Re: Waste Licence Application W 0231-01 Fingal Landfill

In particular I refer to your Point III :- *Based on investigations carried out to date please indicate the potential range of sustainable yields compared to the existing abstraction rates from the Bog of the Ring system, that may be attainable from the area to the South of Decoy Bridge. For the maximum of this range provide a plot of the area of likely zone of influence.*

Site: Nevitt Landfill & Bog of the Ring Well Field
Title: Possible 4. No Well Abstraction Scheme
Drawn: --
Scale: Not to Scale
Job No: --

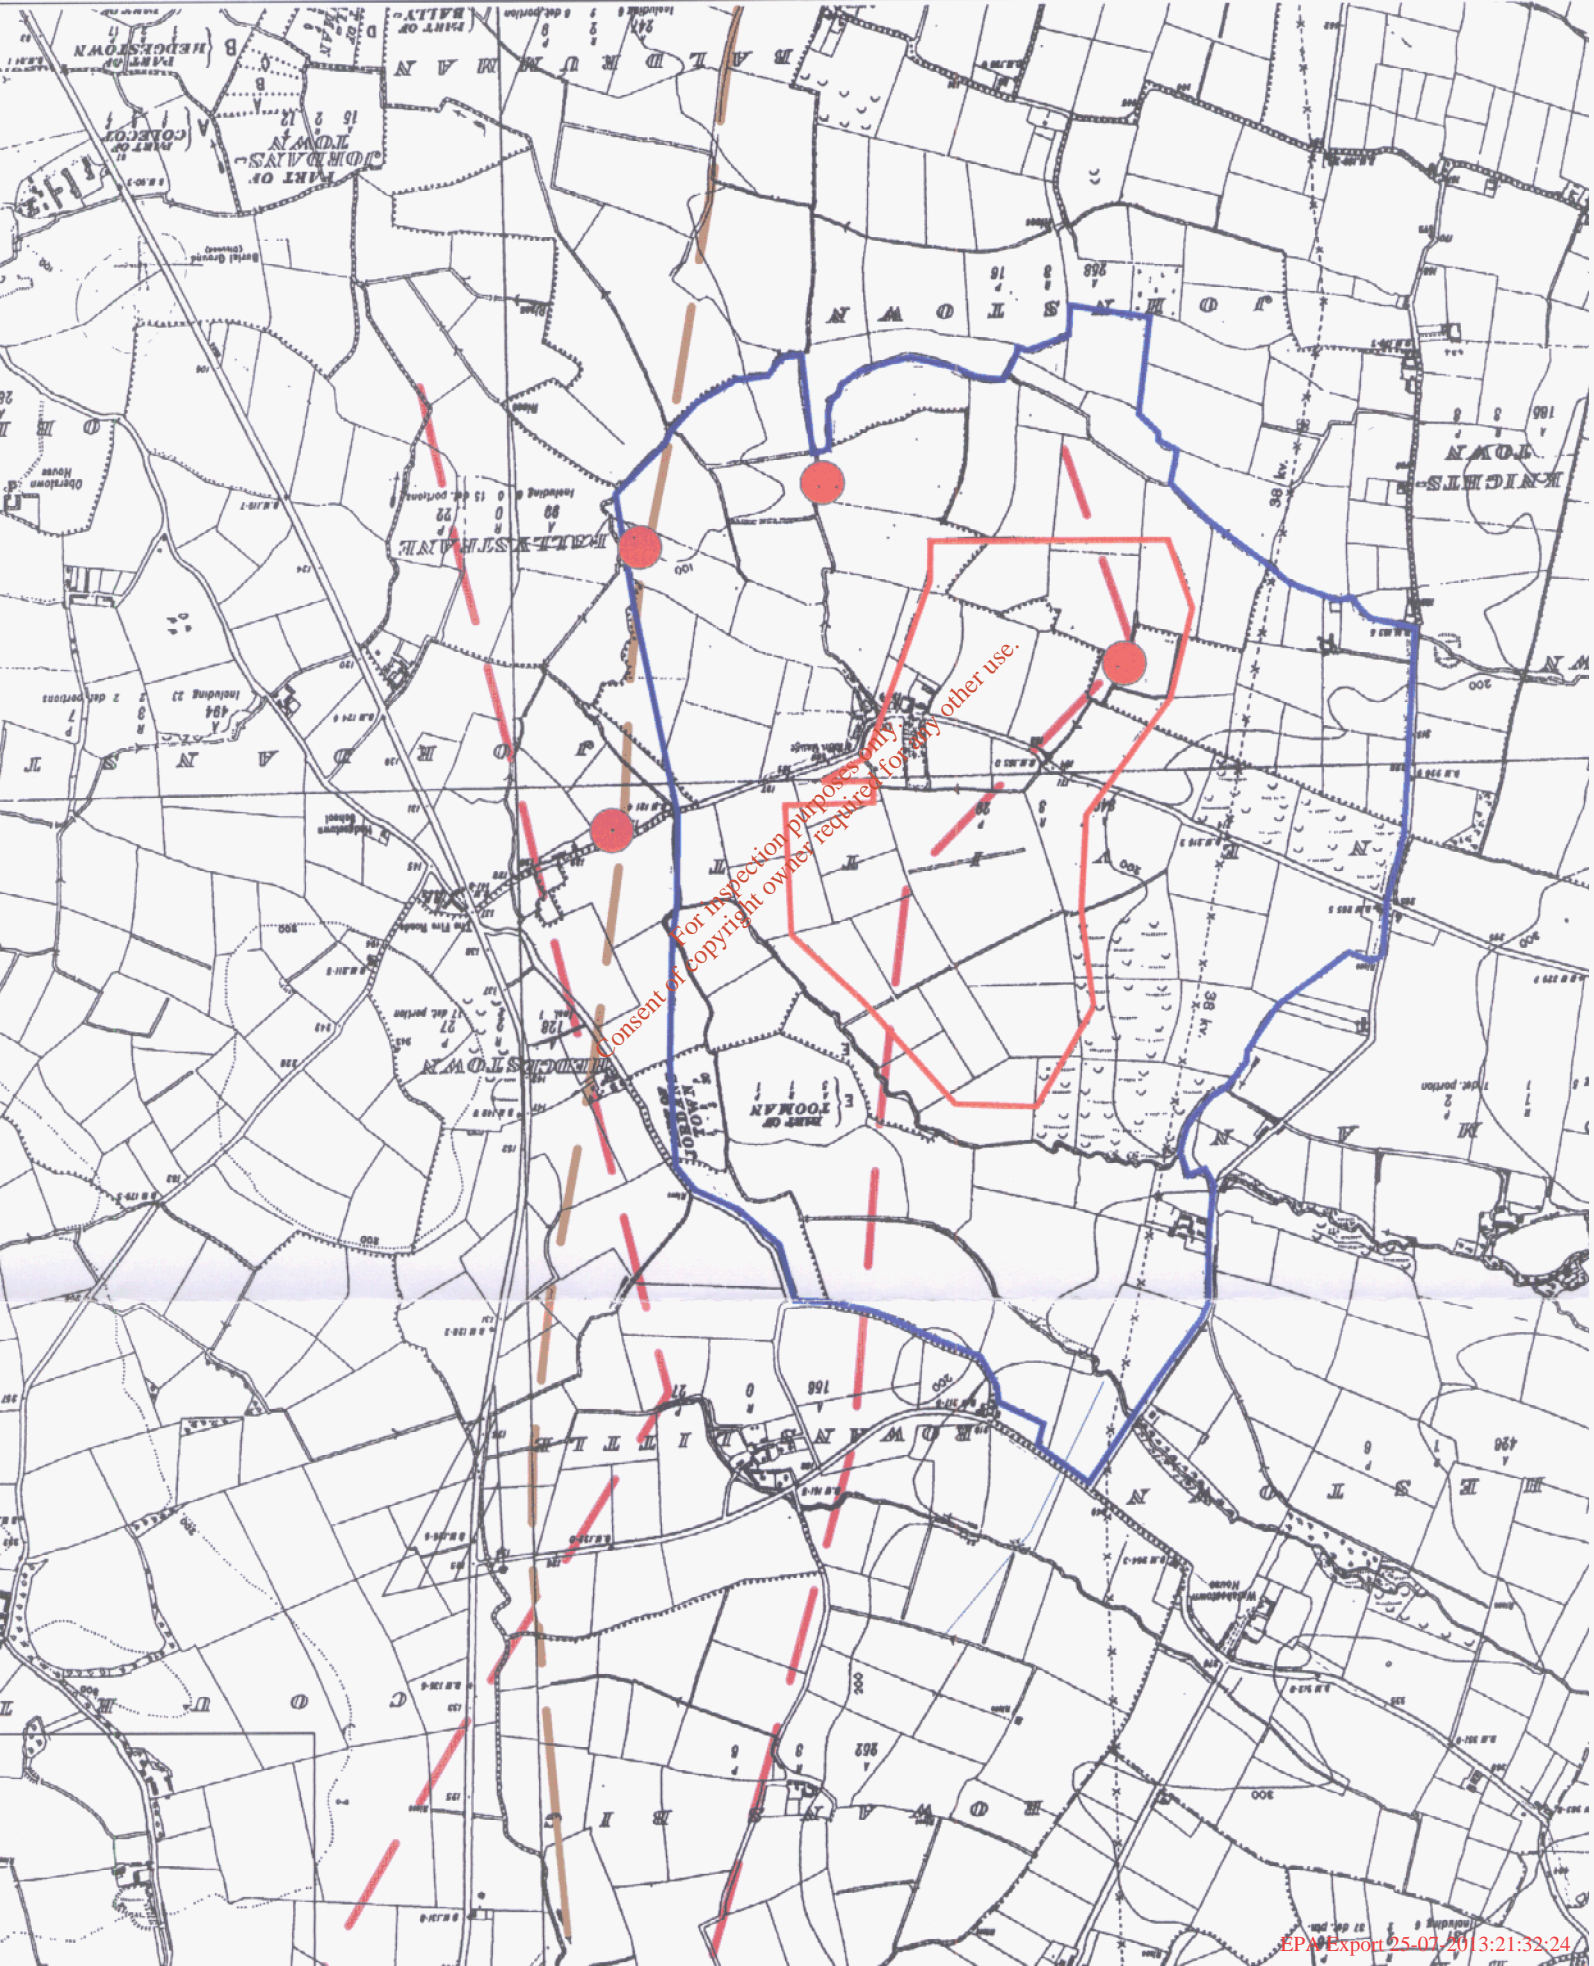
The accompanying map Figure 1 shows the position of 4 No. possible production water wells. These wells (subsequent to trial well drilling) would be drilled to at least 90m, possibly to 120m if required, and with the expectation that each well would be capable of a sustainable yield in the order of 1,000 m³/day or greater.

The Nevitt –Tooman well field would therefore have a projected sustainable yield of c.4,000m³/day, which is similar to the proven capacity of the Bog of the Ring scheme.

The pumped groundwater could be collected by a ring or collector main and pumped via a single main to the nearby Jordanstown Reservoir as indicated in Figures 1 & 2.
